**INTEGRATE SUBSYS INTO 2018 RZR Turbo S, 2019 RZR XP, XP Turbo and Turbo S**  
 subsys-upgrade-2019/rev1

## **MODIFICATION = MOD**

FIG-1-1

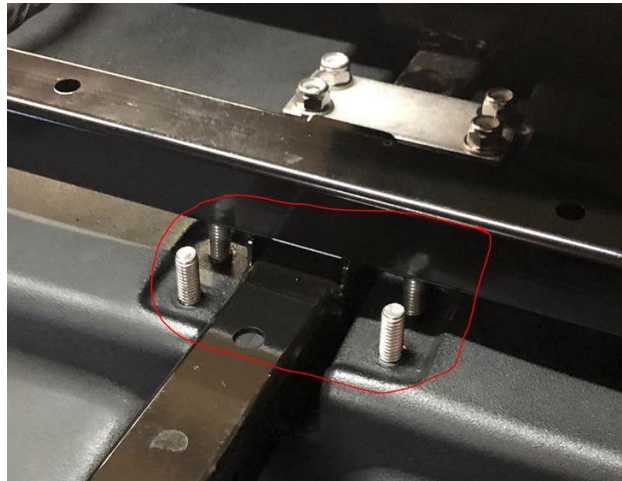
Due to change in the metal work in the dash, the MOD is removing the 4 front studs on the enclosure so that it will clear the support bar in the 2018 RZR Turbo S, 2019 RZR XP, XP Turbo and Turbo S machines as shown in FIG-1-1.

These 4 studs need to be removed with a cutting tool (Air Saw, Hacksaw, Sawzall, i.e) or what other cutting device that you would like to use. After cutting the studs flush go back with a grinding device and clean up the area. After removal the subwoofer enclosure will look like the photo in FIG 1-2.
